**Lower Thames Crossing
9.109 CAH2 Action 3 Response
Franks Farm – Lawson
Planning Partnership / Mrs
Carver**

**DATE: October 2023
DEADLINE: 5**

Planning Inspectorate Scheme Ref: TR010032
Examination Document Ref: TR010032/EXAM/9.109

9.109 CAH2 Action 3 Response

Plate 2.1 Extract from Land Plans Volume C, Sheet 44

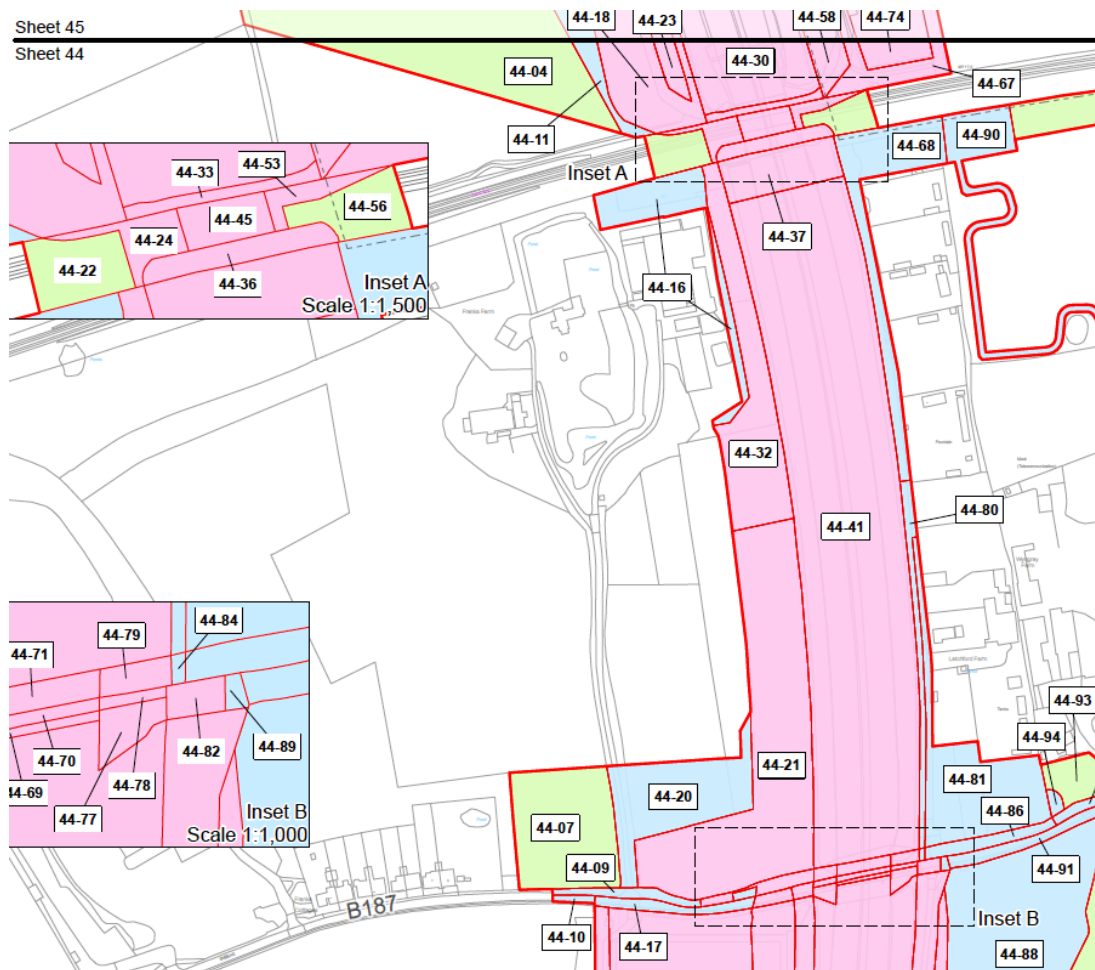
- 2.2.6 Paragraph 18 of the post-event submission on behalf of Mrs Carver [REP4-389] requests that the land required for permanent acquisition in Plot 44-32 is reduced in width adjacent to the retaining wall.

- 2.2.8 Paragraph 17 of the post-event submission on behalf of Mrs Carver [REP4-389] requests that the extent of land to be permanently acquired for the construction of the embankment and the resulting tree loss is reduced.

- 2.4.6 It is therefore not possible to relocate the land required for temporary possession as requested by Mrs Carver in the post-event submission [REP4-389].

- 2.2.7 The Applicant considers it is not possible to reduce the width of the land required for permanent acquisition. The width of the land has already been limited as far as reasonably practicable through the commitment to a retaining wall rather than earthworks to avoid the buildings located to the west. The remaining land is required to enable the construction, within the limits of deviation, of a new one-way, two lane connector road from LTC and the M25 northbound to M25 junction 29 (Work 9D), including the retaining wall and to provide future access for inspection and maintenance.

- 2.2.9 The Applicant considers it is not possible, at this stage of the design, to reduce the extent of land to be permanently acquired for the construction of the embankment. The embankment is of a standard design to meet engineering specifications and is required to enable the construction, within the limits of deviation, of a new one-way, two lane connector road from LTC and the M25 northbound to M25 junction 29 (Work 9D). There are no physical or environmental constraints that justify deviation from a standard design and the increased costs this would entail, at this location.

- 2.2.10 However, following the discussions with Mrs Carver’s agent and the dialogue at CAH2, in order to provide explicit assurance on the considerations the Applicant will make at the detailed design stage, the following commitment has been included in the Stakeholder Actions and Commitments Register submitted at Deadline 5 [Document Reference 7.21 (3)]:

- ‘Embankment at Franks Farm, SACR-011, As part of the detailed design, the undertaker will use reasonable endeavours to minimise the permanent land acquisition and removal of trees as part of the embankment works in Plot 44-32 and 44-21 at Franks Farm.’*

Plate 2.2 Extract from Works Plans (Volume C) Composite, Sheet 44

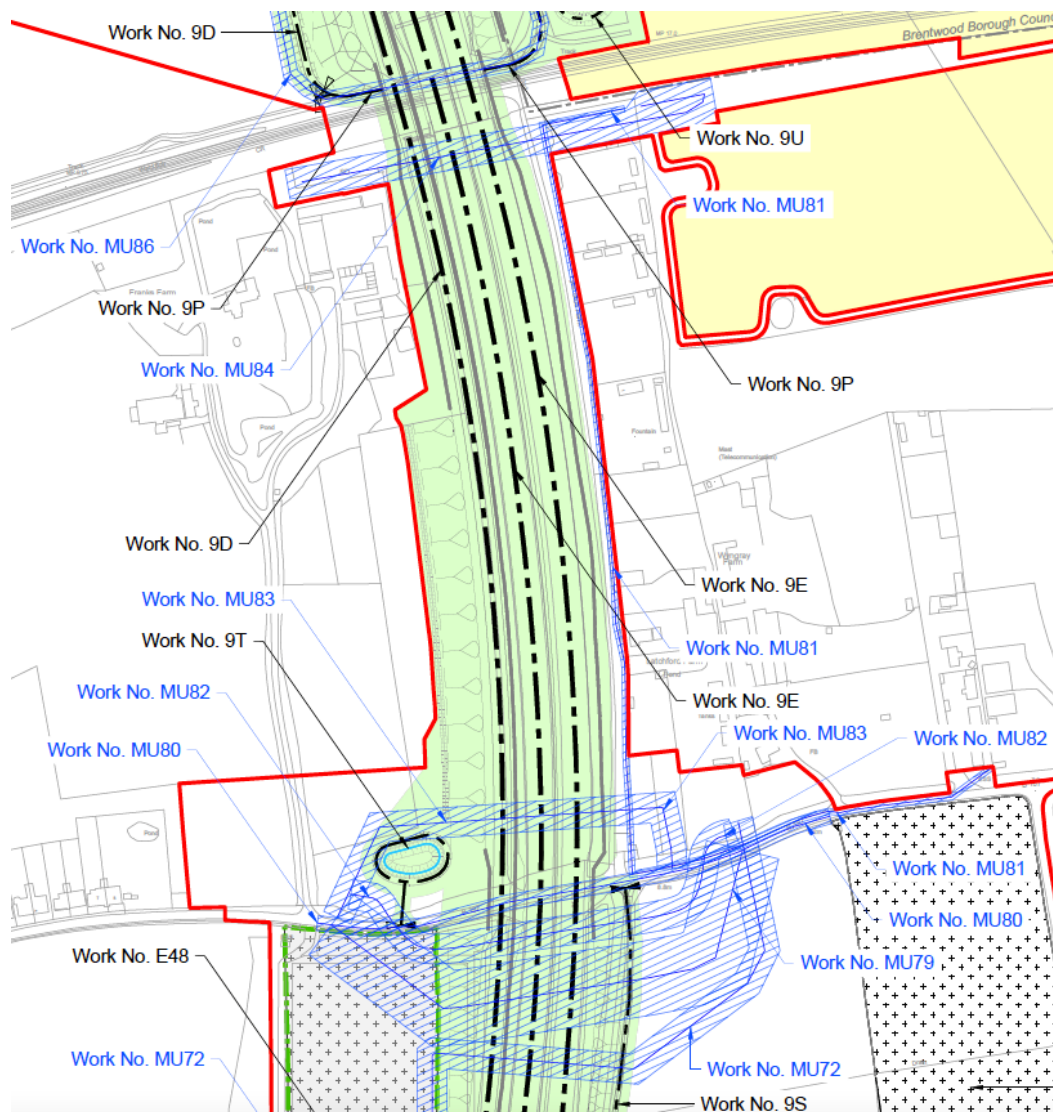
- 2.5.1 As set out above, a drainage pond is proposed as Work 9T as shown on Plate 2.2, on Plot 44-21, as shown on Plate 2.1.
- 2.5.2 Relocation of the drainage pond to land south of St Mary’s Lane has been requested by Mrs J Carver in Relevant Representation [RR-0753] and post-event submission [REP4-389].

‘...The Applicant notes that Mrs Carver also raised a concern about the balancing pond (work 9T), shown on sheet 44 of the Works Plans [REP3-044]. IT explained that the Applicant’s position is that the balancing pond is required at that location and the land subject to acquisition is no more than necessary.

IT explained that the balancing pond cannot be relocated to the land to the south which is to be used for replacement public open space. If the Applicant relocated the balancing pond in this way, the multi-utility works would have to be moved to the north, closer to residential property, in an area where there is already a lot of utilities infrastructure. The Applicant requires the flexibility set out in the limits of deviation to deliver those works.

2.5.4 Following the discussions with Mrs Carver’s agent and the dialogue at CAH2, in order to provide explicit assurance on the considerations the Applicant will make at the detailed design stage, the following commitment has been included in the Stakeholder Actions and Commitments Register submitted at Deadline 5 **[Document Reference 7.21 (3)]**:

‘Drainage Pond (Water 9T), SACR-010, As part of detailed design, the undertaker will use reasonable endeavours to minimise the permanent land acquisition associated with the drainage pond at Franks Farm (Work 9T) including considering its location (provided that is consistent with the powers under the DCO.’

Plate 2.3 Extract from General Arrangement Plans Volume C, Sheet 44

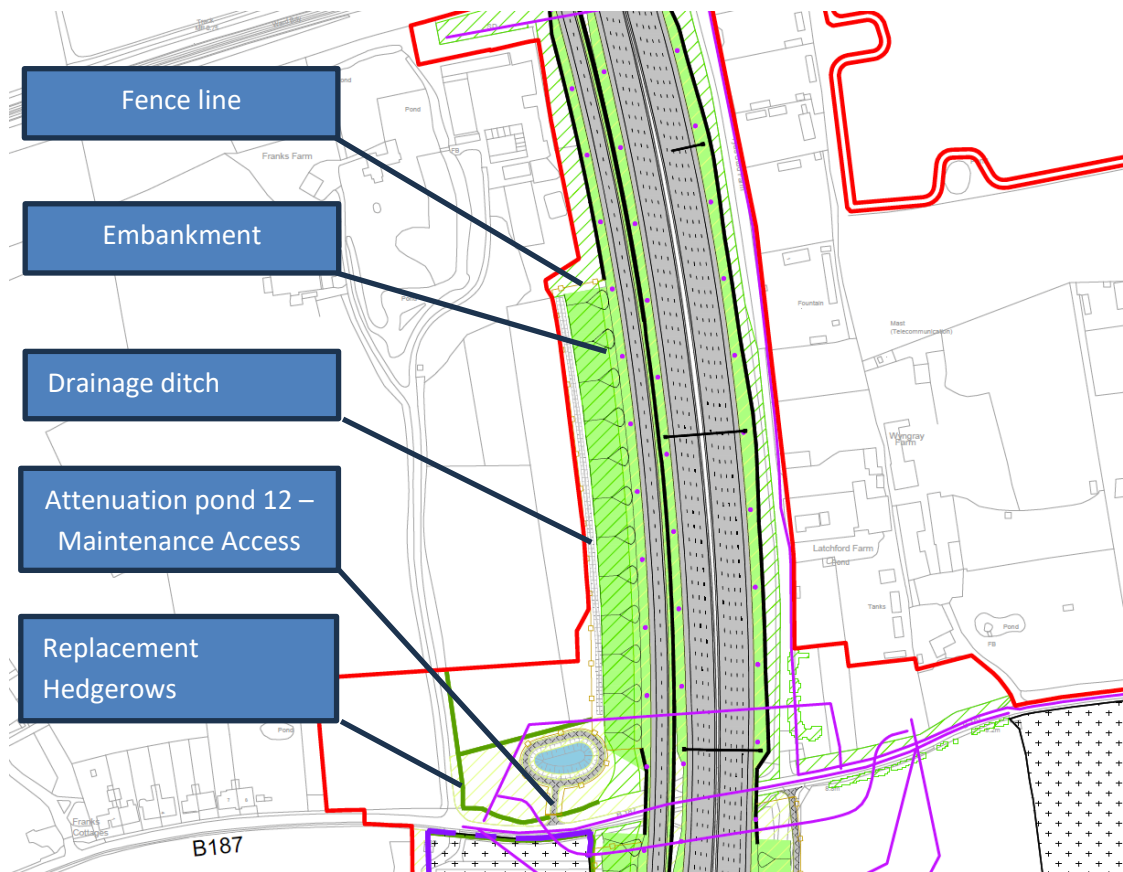
2.6.1 Paragraph 19 of the post-event submission on behalf of Mrs Carver [\[REP4-389\]](#) requests the *‘provision of a dual-purpose access drive to serve the operational highway land on the eastern boundary of the property and the courtyard area framed in part by the curtilage listed buildings, to be used for commercial office and leisure uses... The intention would be for this to be aligned on the western side with a 2 metre high solid timber fence to allow for privacy and security’*. This followed discussion at CAH2 regarding a shared access for maintenance and commercial use as shown by the pink based line on Plan Showing Existing Context & Requested Dual Access & Reinstated Barn [\[AS-152\]](#).

2.6.2 The Applicant has reviewed the proposed operational access arrangements for the Project in this location and there appears to have been a misinterpretation of the Project proposals by Mrs Carver regarding a proposed maintenance vehicle access track.

2.6.3 No vehicle maintenance access is proposed along the embankment and therefore there is no opportunity to create a ‘shared access’ as requested, nor is

there a requirement for a timber fence for privacy. There will however be a boundary fence and replacement hedgerows. This is illustrated below in Plate 2.3 which is an extract from General Arrangement Plans Volume C (sheets 21 to 49) [REP3-031] Sheet 44 with labels added to key features.

- 2.6.4 Whilst maintenance vehicle access is proposed as part of Attenuation Pond 12 (Work No. 9T) adjacent to St Mary's Lane, this only provides infrequent maintenance access to the attenuation pond. The Applicant only requires foot access to the embankment and retaining wall for maintenance and inspection purposes.
